National Highways Planning Response (NHPR 25-01) Formal Recommendation to an Application for Planning Permission

Council's Reference: AWDM/0460/26

Location: 120 Upper Brighton Road, Worthing, West Sussex BN14 9JB

Proposal: Proposed extension to width of vehicular access

(Source: DMRB)

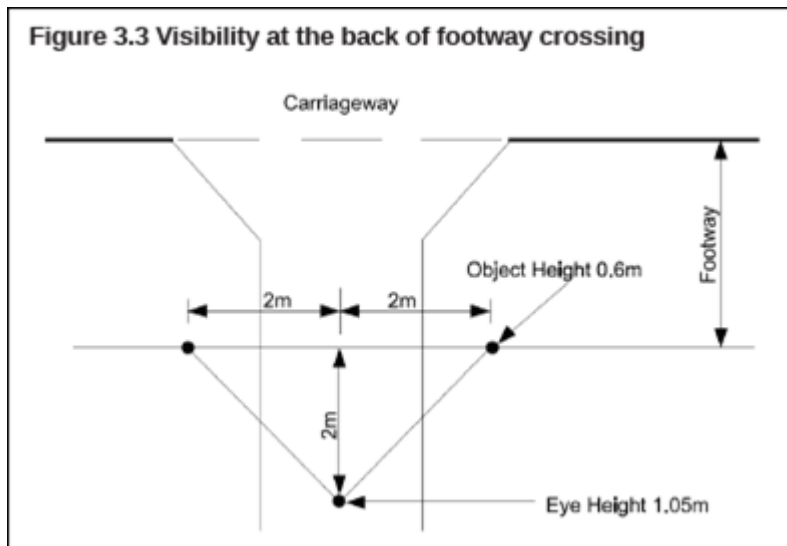
As the A27 is part of the SRN, visibility splays measured from the edge of carriageway must be in accordance with the standards in the Design Manual for Roads and Bridges. **The applicant will need to provide visibility splays which are required to be shown in full as per DMRB CD 123 to ensure that the visibility splays are clear of obstructions.**

Clause 3.3 of DMRB CD 123 states that “where a direct access crosses a footway, a visibility splay shall be provided in accordance with Figure 3.3”. Figure 3.3 is shown below. A clear visibility splay measured from a point 2m from the rear of the footway, in each direction for 2m shall be provided.
